SUBJECT: Use and Bulk Variance Application No. ZB-9/20
Major Site Plan – Preliminary & Final Approval Application No. SP-11/20
Mitch Brown, Circle Management, Inc., 1652 Princeton Avenue
Tax Map Page 1, Block 103, Lots 66, 67 and 68

DATE: July 12, 2021

Re: **Mitch Brown - Circle Management, Inc.**
Floor Area Ratio and Bulk Variances
Preliminary and Final Major Site Plan
Block 103, Lots 66, 67, and 68
1652 Princeton Avenue
Neighborhood Center 1 (NC-1) District
Application No. ZB-9/20

Date: August 18, 2021

Proposed Building Front Façade

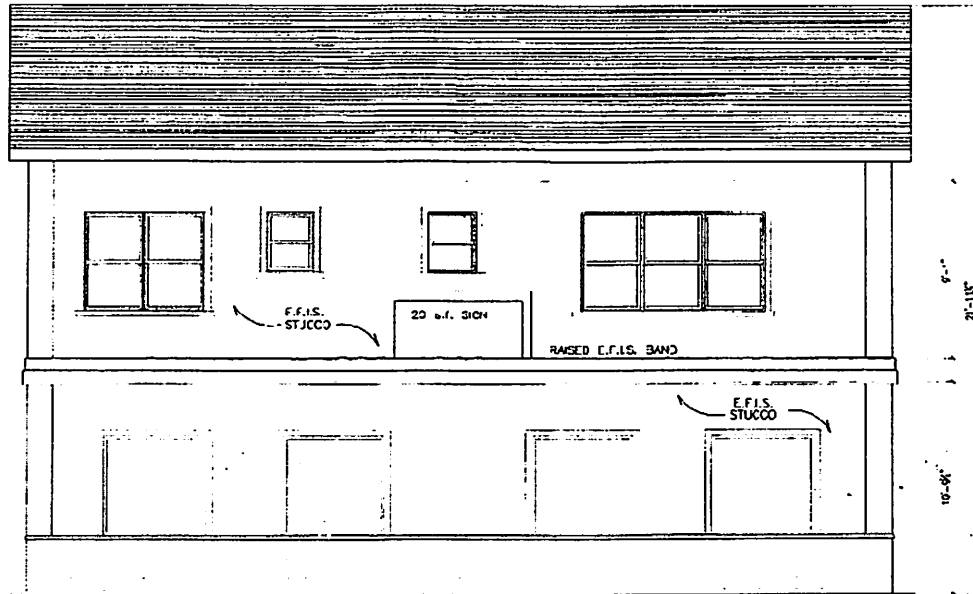
- 7.1 Proposed Elevations. The proposed facades of the building reflect a commercial design intent. On Princeton Avenue, which the long side of the building faces, there is a mixture of commercial and residential buildings. The residential buildings are typical of the post-World War I era with brick first stories and porches, with clapboard upper stories. In many instances the porches have been enclosed for more interior space with clapboard or other wooden material and traditionally painted white. The commercial buildings are all one-story excepting those that have been converted from residences and typically have flat roofs with a smattering of gable-roofed structures. Their facades are almost universally stucco and some have a base of masonry. The masonry bases are split face architectural block or stone veneer. Consequently, the proposed exterior materials proposed are consistent with the other commercial building on the Princeton Avenue corridor. Buildings should be compatible with neighboring areas through attention paid in the architectural design process to scale, size,

style, placement of doors and windows, its form, color, and exterior materials (§536.A.2). Here, the architect has created a base, middle and top to the building, as well as added an accent line to distinguish between the first and second floors. These components are recommended in the Township's commercial building design guidelines, and the gable roof is required for certain commercial buildings under 6,000 sf. in area. Consequently in our view, the exterior building design meets the ordinance standard.

- 7.2 Windows. There should be an attempt to standardize the windows in the façade among the residential and commercial floors. In the elevations that have been presented, two incompatible types are proposed.
